SUBDIVISION COMMITTEE
METROPOLITAN AREA PLANNING COMMISSION

STAFF REPORT
(Final Plat)

CASE NUMBER: S/D 89-88 - KILLARNEY PLAZA FOURTH ADDITION

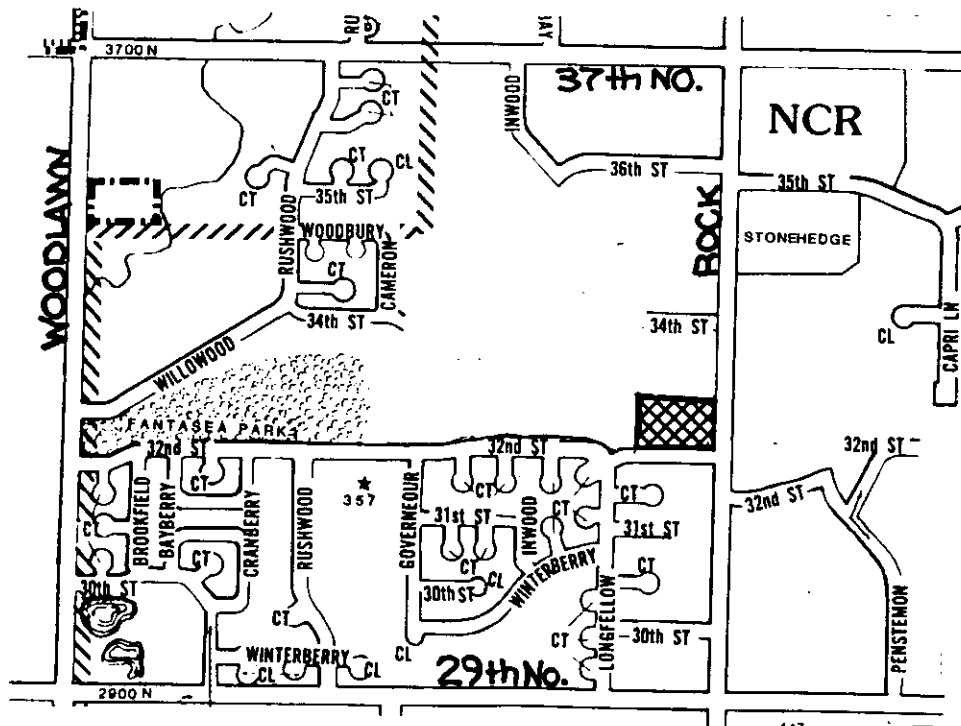
- NOTE: This plat was submitted in final form and is a replat of Lot 3, Block 1, Killarney Plaza Third Addition. The area of the plat is within Parcel 2 of the Commercial Community Unit Plan W.D.C. Parcel 11A & 12 (DP-158).

- E. The applicant proposes a joint access easement to provide Lot 1 with access to 32nd Street North across Lot 2. The proposed joint access easement will need to be established by separate instrument with appropriate recording information indicated on the final plat tracing. Prior to recording the joint access easement, a draft shall be submitted to the Planning Department for review and approval. The instrument must clearly state the purpose of the easement as well as which properties benefit from the easement. Initial construction responsibilities and future maintenance of the driveway within the easement should also be addressed by the text of the instrument.

- F. The associated CUP (DP-158) provides only one opening to this track to and from Rock Road. The plattor's text indicates Lot 2 is to have the one allowed opening. The final plat tracing shall indicate complete access control along the east line of Lot 3 and make the appropriate reference in the plattor's text.

- H. The wall easement shall be removed from within the 20 foot drainage easement or the applicant shall submit a hold harmless agreement, acceptable with City Engineering, to the Planning Department prior to this plat being scheduled before the City Council.
-

- I. The platlor's text shall make reference that a 5.00 "foot" wall easement is being granted. The text presently makes no reference to the standard of measurement.
